**ADDENDUM NO. 4**

Date: September 14, 2018  
Project: **Secondary Treatment Plant Upgrade & Recycled Water Expansion**  
Job No.: 12600-07/16650-02

SHEET 95 OF 159	PLAN NO.	DRAWING NO. <b>LE-03</b>	REVISION NO. <b>B</b>
--------------------	----------	-----------------------------	--------------------------

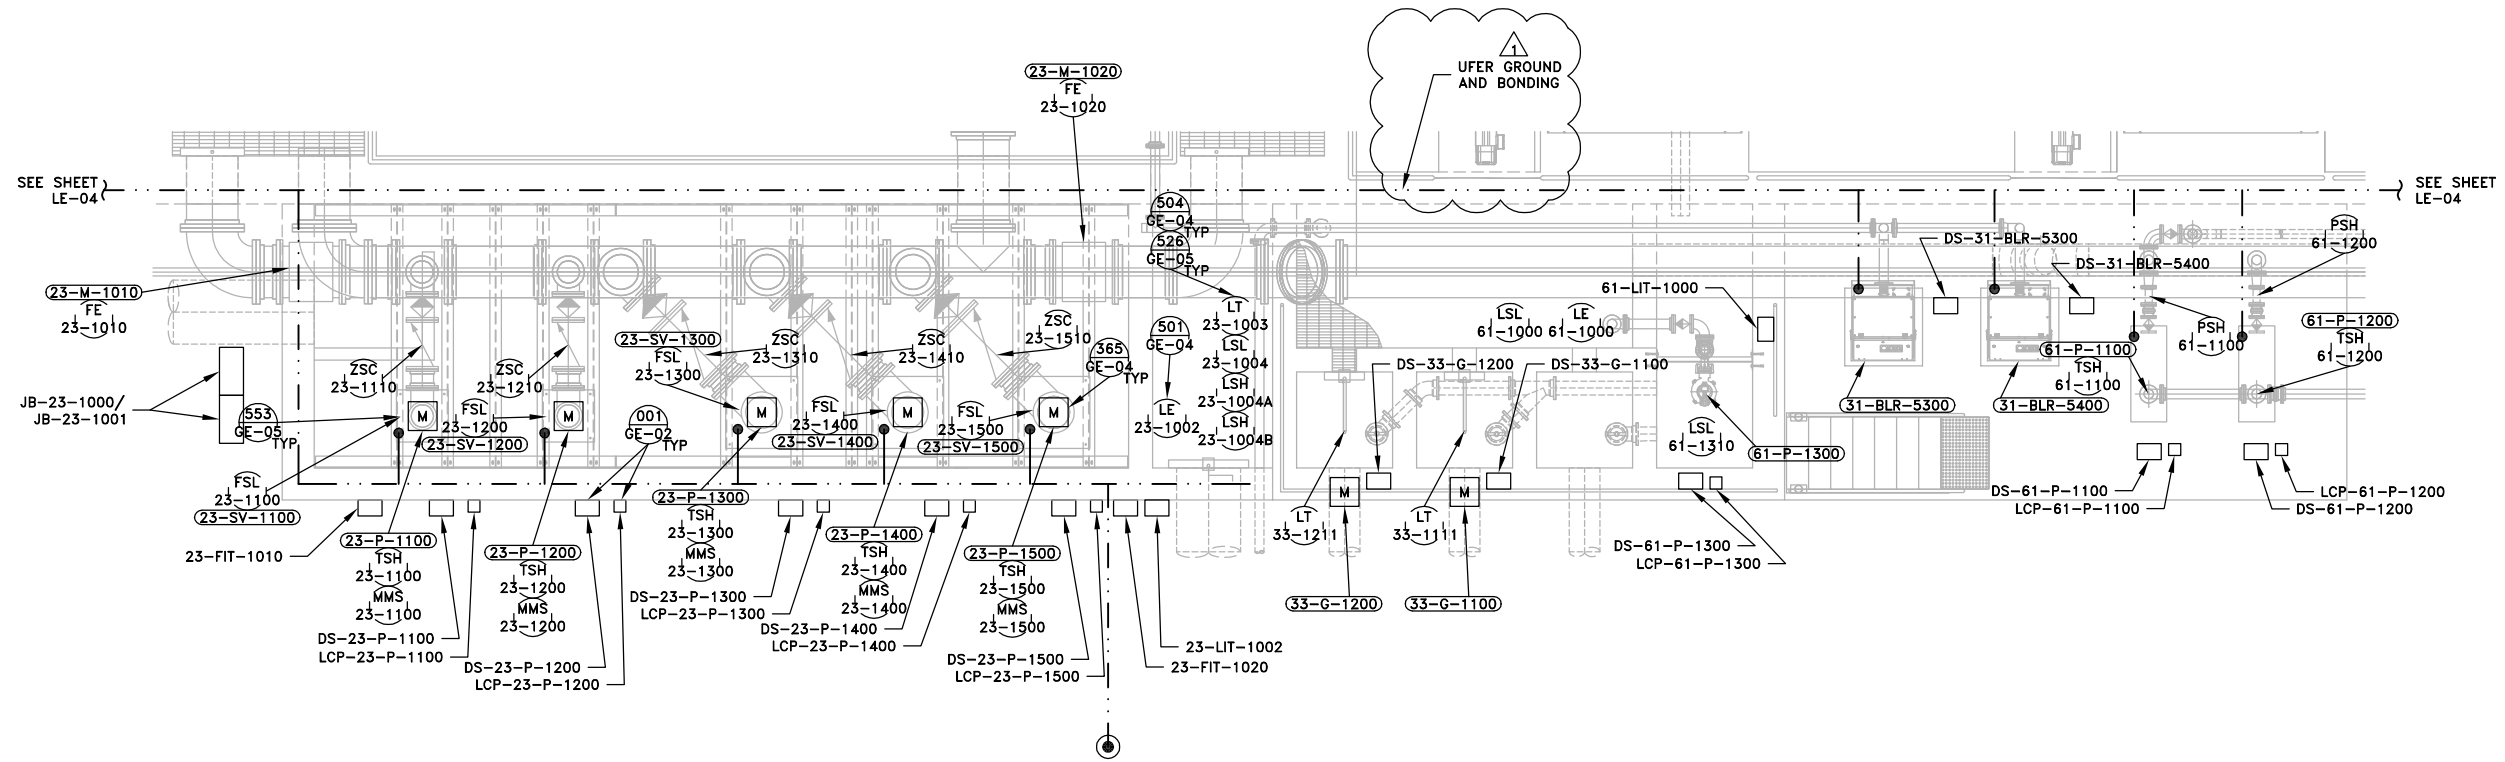
3. **Sheet LE-02, LE-03, LE-04, LE-10 and LE-14:** Have been re-issued to show more detail on grounding. Grounding of structure and major process equipment is shown. Contractor is still responsible for grounding metal surfaces such as hand rails and roofs to the UFER ground.

SHEET 96	OF 159	PLAN NO.	DRAWING NO. LE-04	REVISION NO. B
-------------	-----------	----------	----------------------	-------------------

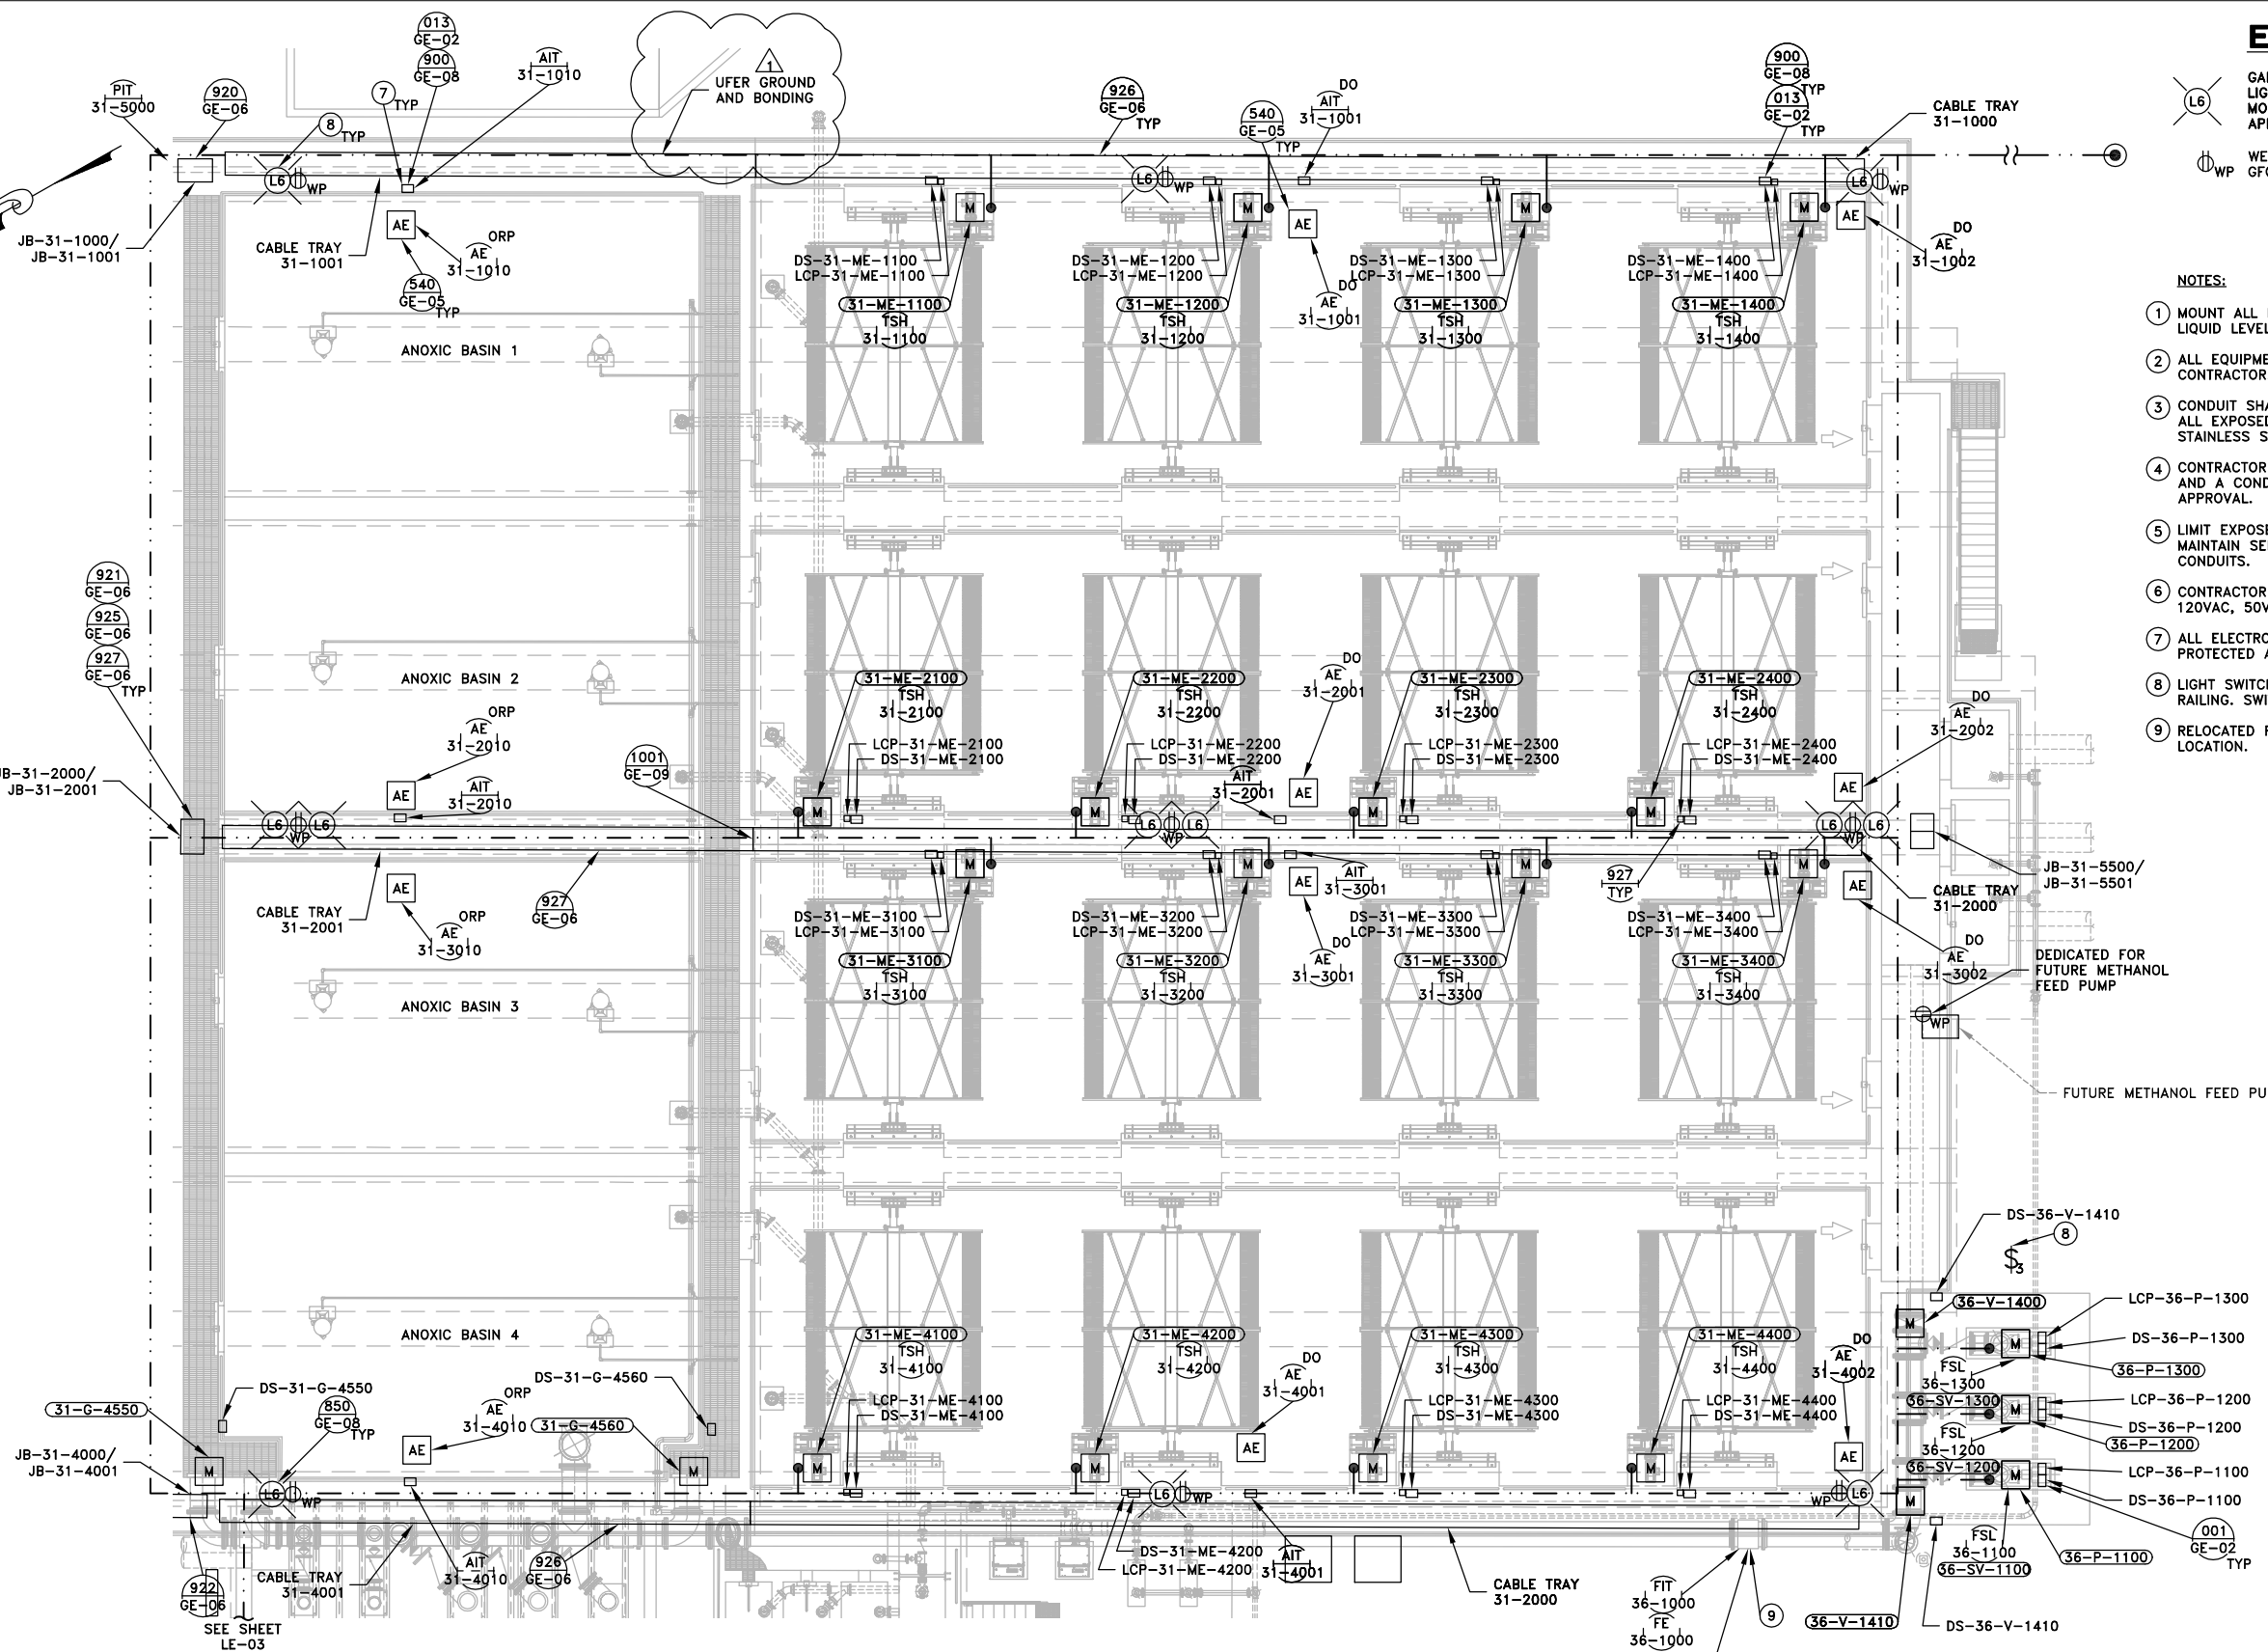
7. Drawing LE-04 - There is a callout to Note 7 (Typical) to a light fixture in the upper left hand corner of this drawing. Is this a mistake? Also Note 7 calls out Detail 921 on Drawing GE-08. That detail does not exist. Please clarify.

**Answer: The callout should be Note 8 instead of Note 7. Also the referenced detail 921 should be corrected to 901.**

SHEET 128 OF 159	PLAN NO.	DRAWING NO. E-19	REVISION NO. B
---------------------	----------	---------------------	-------------------

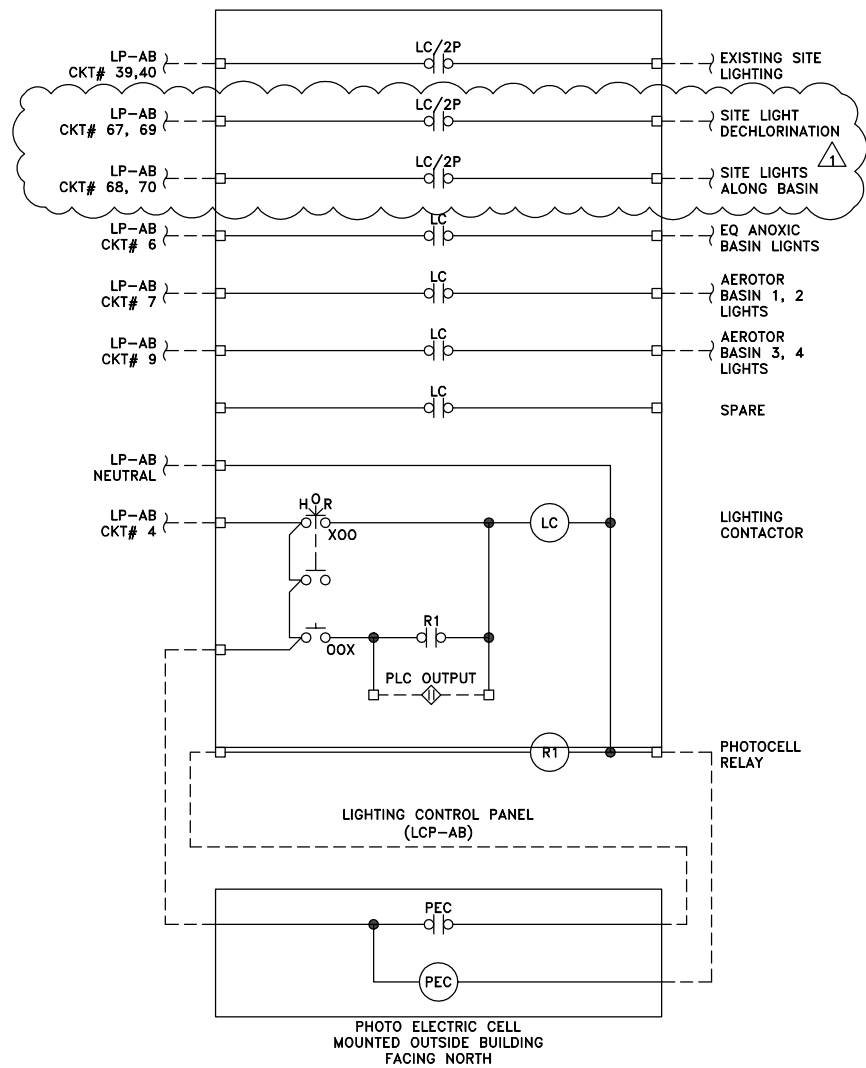
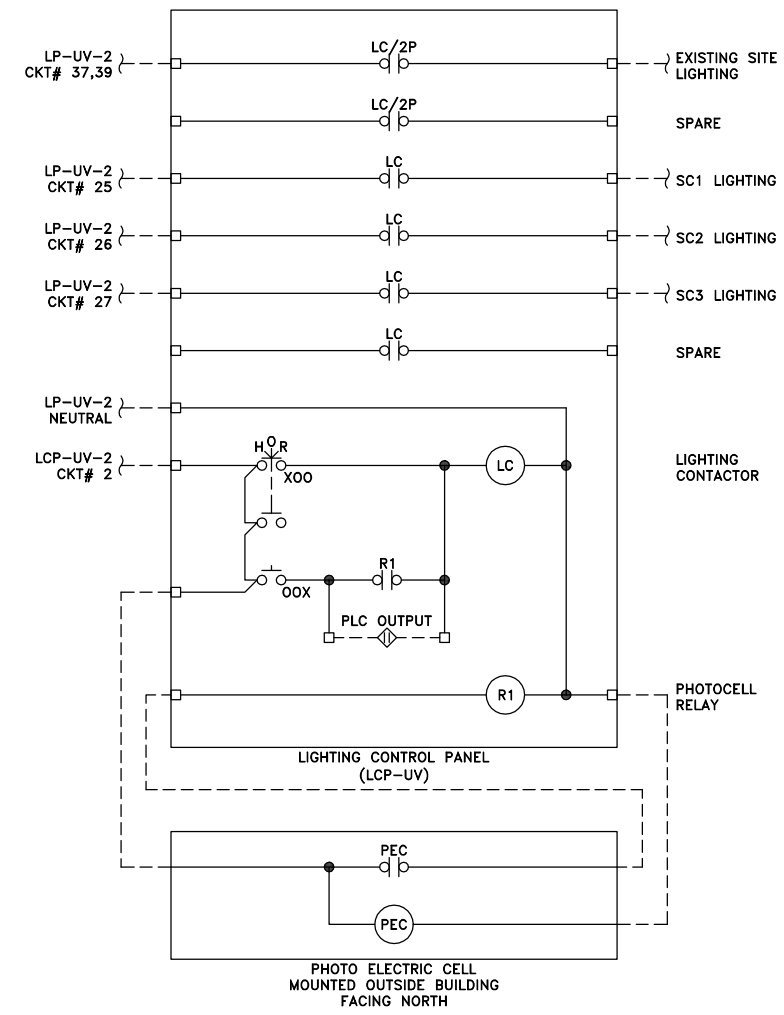
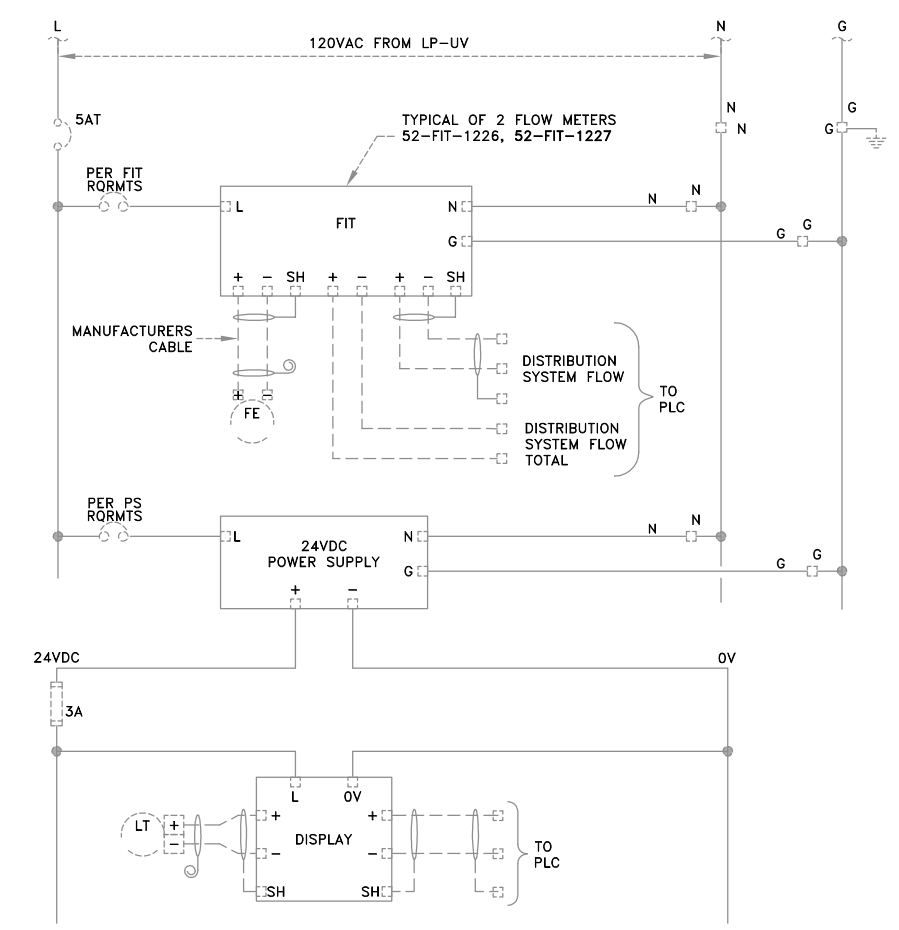
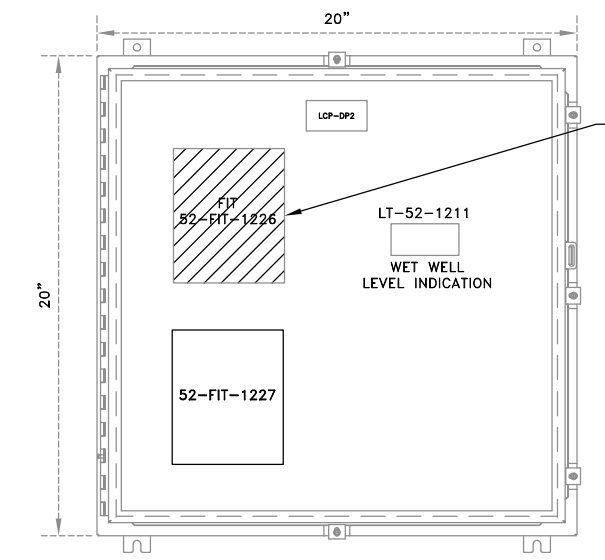
6. **Sheet E-12:** Sheet has been re-issued to show the loads for site lighting.
7. **Sheet E-19:** Modified lighting control panel to account for added site lights.
